MEMORANDUM

REVIEW TYPE: Site Plan Review
APPLYING FOR: Approval of 156,500 new square feet of commercial office space and 342,500 square feet of existing office space for a total of 499,000 square feet of office space and reduction of parking setbacks

PROJECT NAME: Century Technology Campus at Cloverleaf Center
CASE #: 8-03007
REVIEW BASIS: Division 59-D-3, Site Plan required in the I-3 Zone
Section 59-C-5.34(a)(3)(footnote 4), Parking Setback Reduction

Detail showing pedestrian-vehicular conflicts at entrance driveways

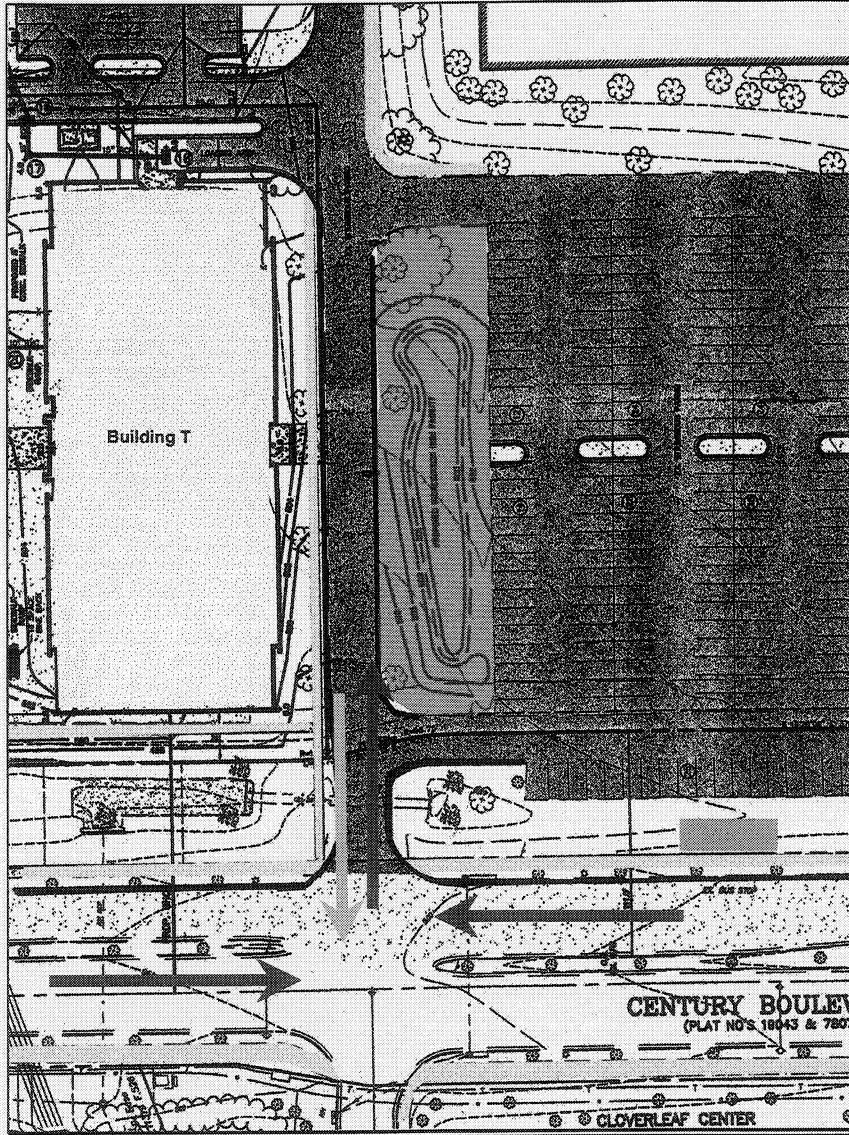
The pedestrian system is problematic with regard to adequate connections and safety. See Findings on page for full discussion.

No improvements are proposed to the existing pedestrian circulation despite the increase in parking capacity and office space area. Lead walks are provided to the new buildings from the existing paths.

Pedestrian circulation as proposed is problematic. Significant safety issues are inherent in the sidewalk system, namely the sidewalk paths on only one side of the drives proposed to carry pedestrians from Century Boulevard to the nine buildings. For example, pedestrian access proposed at the vehicular entrance between Parcel T and the surface parking at Century Boulevard, requires the pedestrian walking from the bus stop to cross the entrance drive which serves both left-turn and right-turn traffic movements both into and out of the site (a 4-way movement). A similar condition is proposed at the vehicular entrance to the south at Parcel V.

Staff recommends, per Transportation Planning and Community-Based Planning (memoranda attached), with the recommendation of the MC Department of Permitting Services, that sidewalks be provided on both sides of the vehicular entrance drives to provide an adequate measure of pedestrian safety, and to create an efficient and usable pedestrian system.

*Landscape Plan showing connecting green space to be replaced with parking.
Staff Recommendation 4(b)(i) addresses the pedestrian connections and tree planting.*

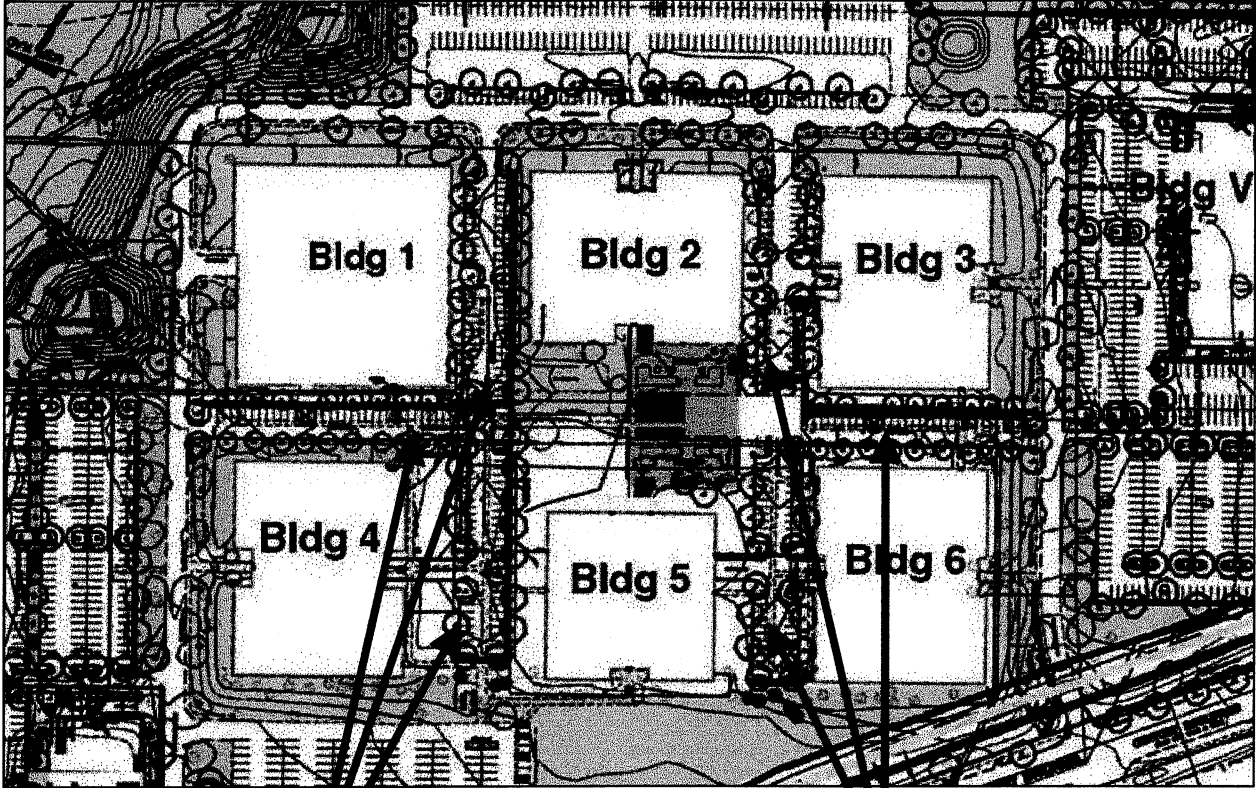
The existing campus green that forms the heart of the building cluster has been retained as part of the site plan. It is, however, significantly impacted by the addition of 262 head-in parking spaces that replace the connecting interstitial green spaces that enhance the pedestrian amenities of the campus. Staff recommends (Condition 4(b)(i)) that two of the six driveway lanes be reconfigured to accommodate a traditional streetscape: sidewalks on both sides, street tree panel at the curb, full shade trees to mark the primary pedestrian routes.
